## Intel<sup>®</sup> 80331 I/O Processor

**Specification Update**

April 2006

### Table 236. DDR SDRAM Control Register 0 - SDCR0 (Sheet 1 of 2)

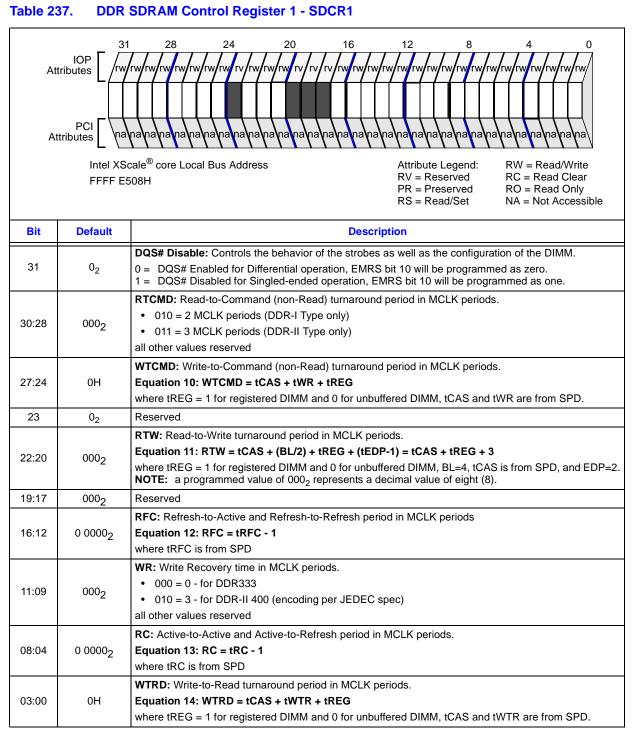
31:28	0Н	<b>RAS:</b> Active to Precharge duration in MCLK <b>Equation 7: RAS = tRAS - 1</b> where tRAS is from SPD	periods	
27	0 <sub>2</sub>	Reserved
